**CERTIFICATE OF APPROPRIATENESS**

**Property:** 1913 A Crockett St, Lot 11A, Block 314, Crockett Street Landing Subdivision. The property is a vacant lot, subdivided into two lots – 1913-A, which fronts on Crockett St, measures 2,534 square feet (51’ x 50’-4”); 1913-B at the rear is 1,608 square feet (37’-8” x 42’-8”).

**Proposal:** New Construction – Residence/Garage *Deferral*

**Recommendation:** Deferral

BLOCKFACE SITE PLANS

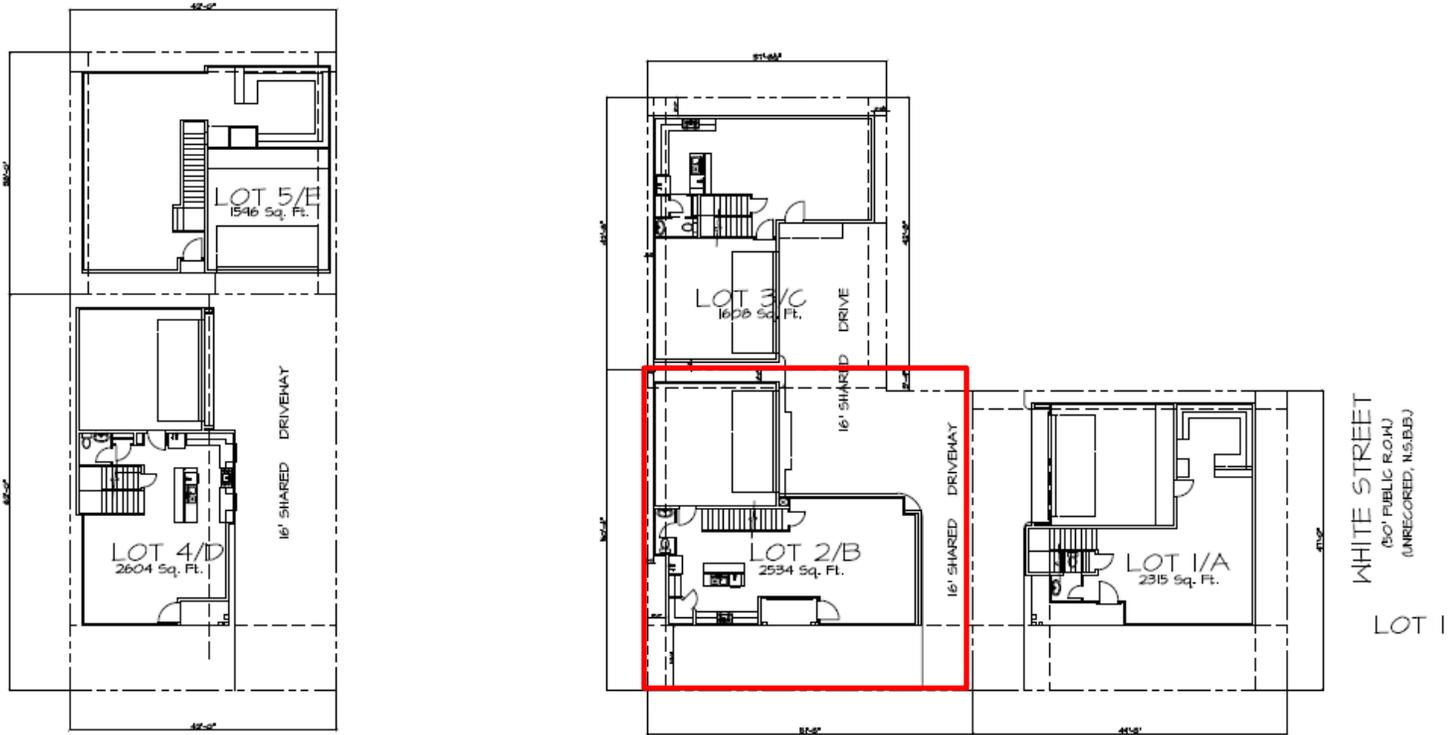
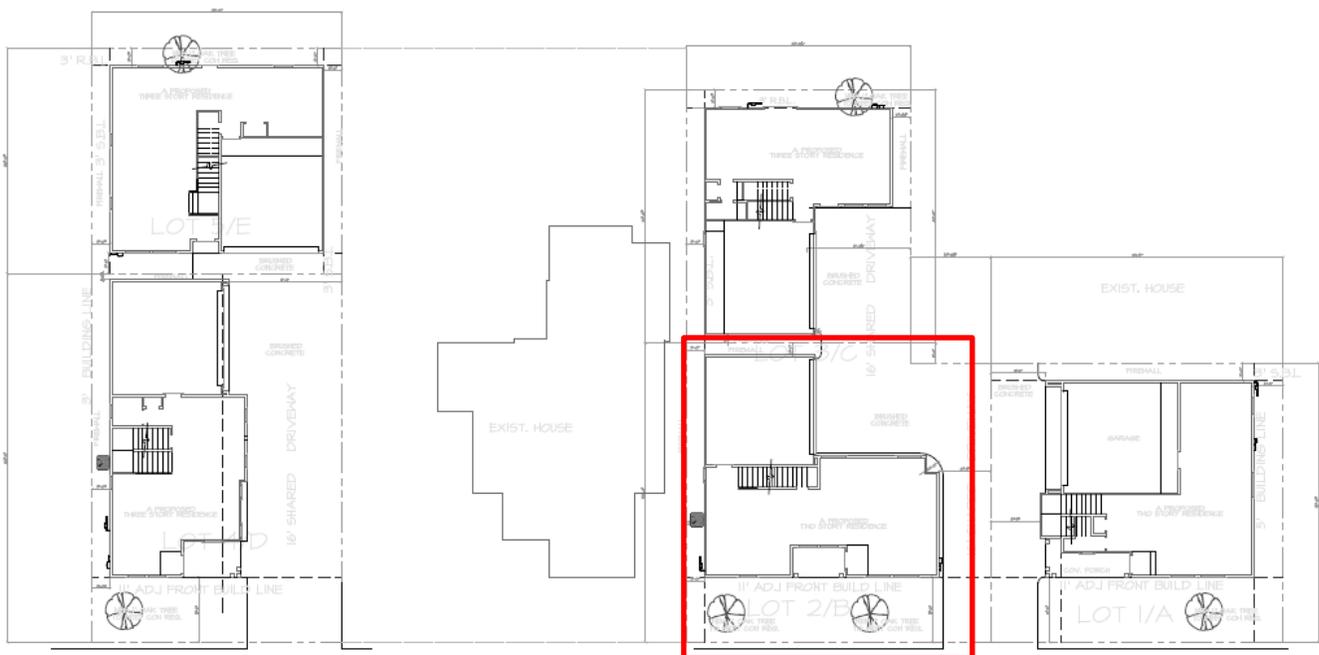
- There is one contributing structure on this blockface that has a setback of 11'. The current proposal has a setback of 10'. The proposed east side setback is 3', placing the residence roughly 6' from the nearest point of the contributing structure at 1907 Crockett.*

**NORTH ELEVATION – FRONT FACING CROCKETT STREET**

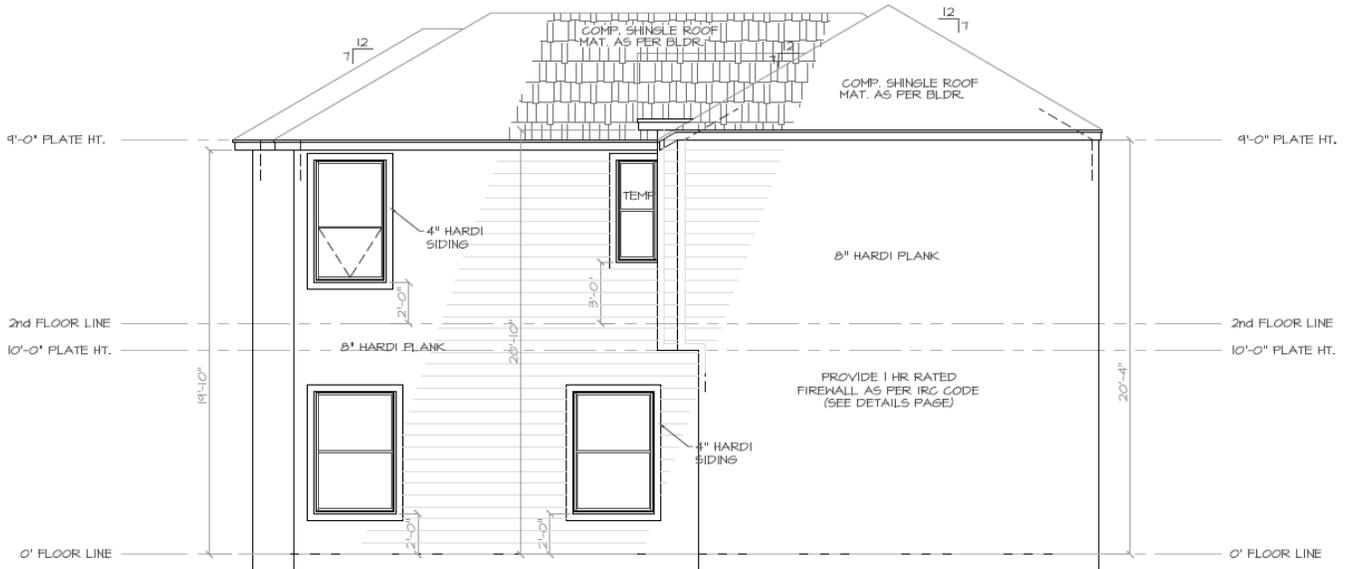
- The inset front porch is approximately 5' deep. Feedback from the Commission at the February 2016 meeting included that the 1907 Crockett Property not be overwhelmed by a blank wall on the west side. Staff suggested deepening the porch and extending it across the front wall on the eastern portion to create this effect. The applicant installed a shed roof on the front, but did not inset the wall to the compatible depth of 6'.*

- The residence has a 39'-6" overall width, which is wider than the typical 32'-39' widths of contributing structures within the context area. However, the ridge height is within range of contributing two-story structures at 27' high, and the porch height and first floor plate heights are in-line with the one-story contributing structures within the context area.*

- If the residence were reduced to a width between 36 and 39, the project would meet this criterion.*
- (4) The height of the new construction must not be taller than the typical height of existing contributing structures in the context area unless special circumstances, such as an atypical use, location, or lot size, warrant an atypical height, except that;

**EAST SIDE ELEVATION**

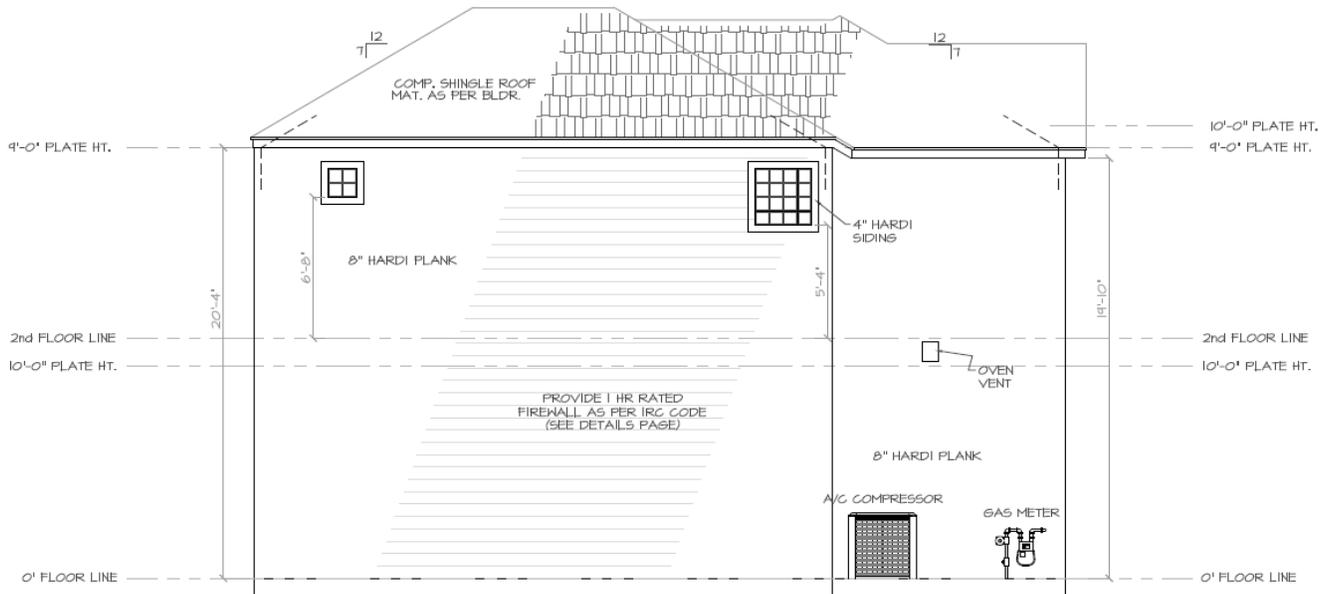
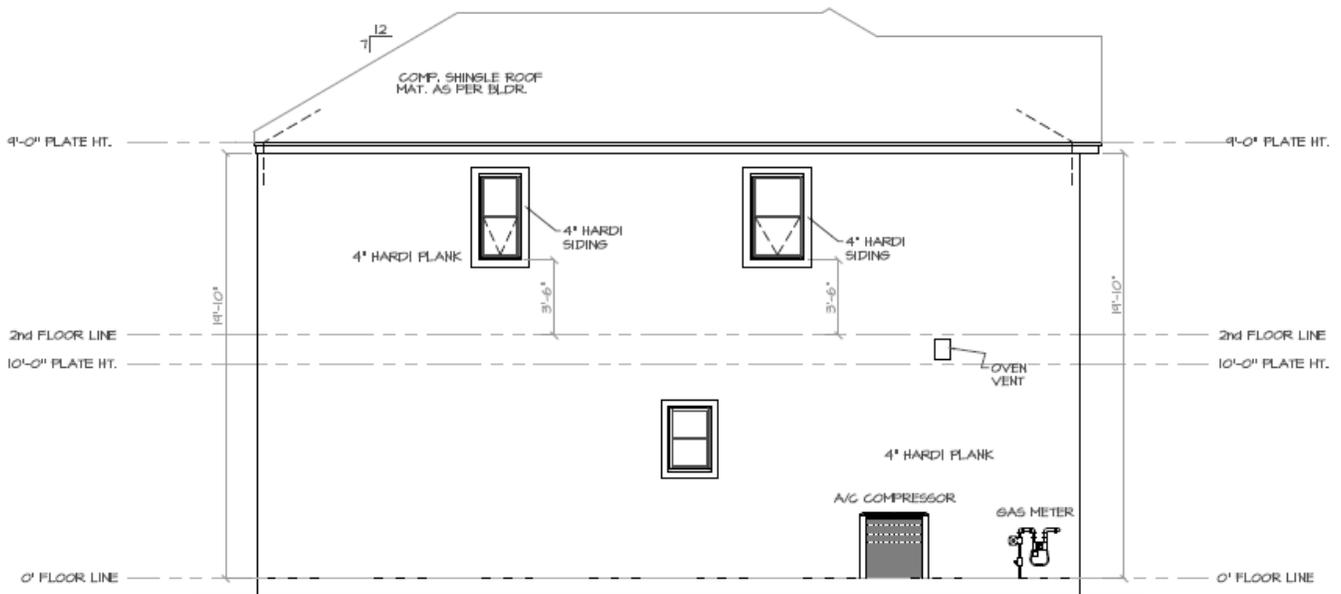
- The residence is clad in 4" smooth-finish cementitious siding.*
- The east elevation and the portion of the west elevation visible from the street are lacking window openings in keeping with typical contributing structures in the area. These blank walls do not meet Design Guidelines provisions requiring traditional solid-to-void proportions for walls to windows.*

- If the applicant created a usable porch on this elevation and added symmetrical windows on the east and west elevations, the project would meet this criterion.*

WEST SIDE ELEVATION

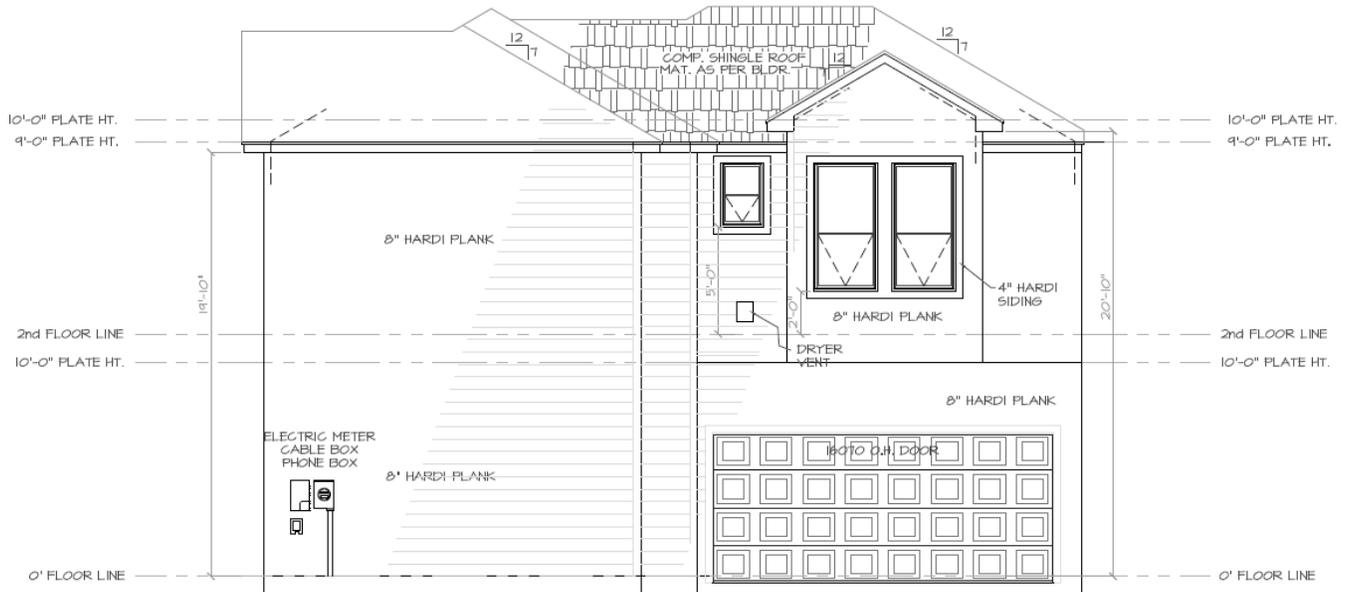
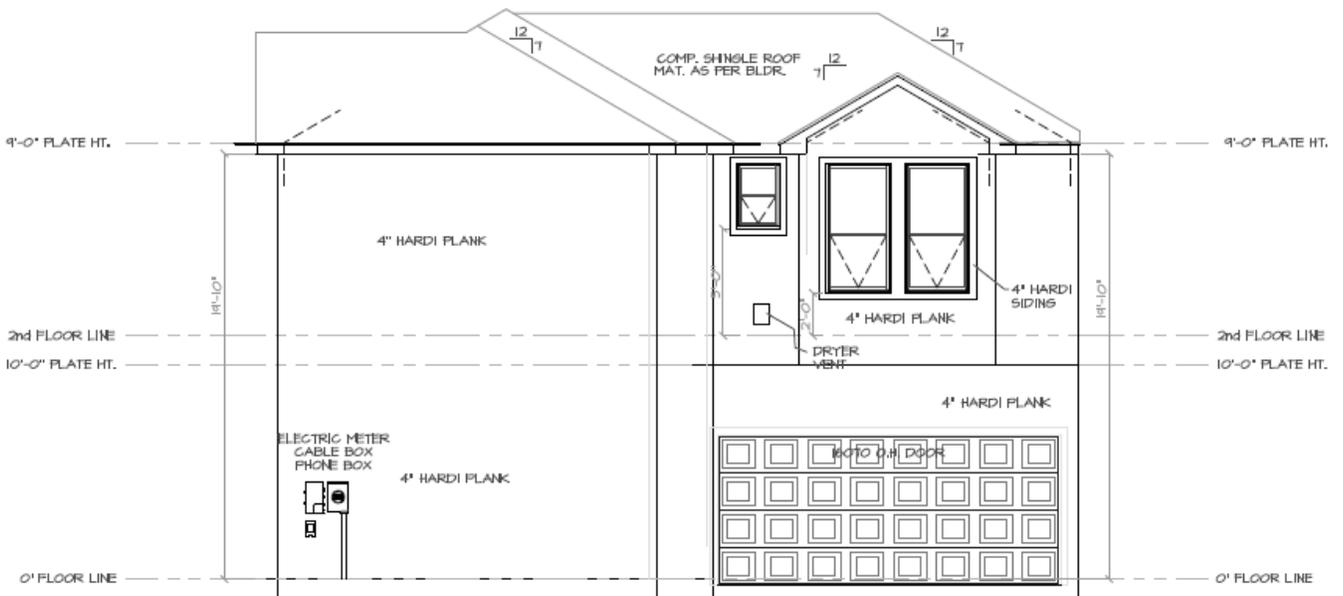
*The draft Design Guidelines also require traditional solid-to-void proportions for walls to windows. The east and west elevations visible from the street lack window openings, which is not in keeping with typical contributing structures in the area and therefore does not meet this provision.*
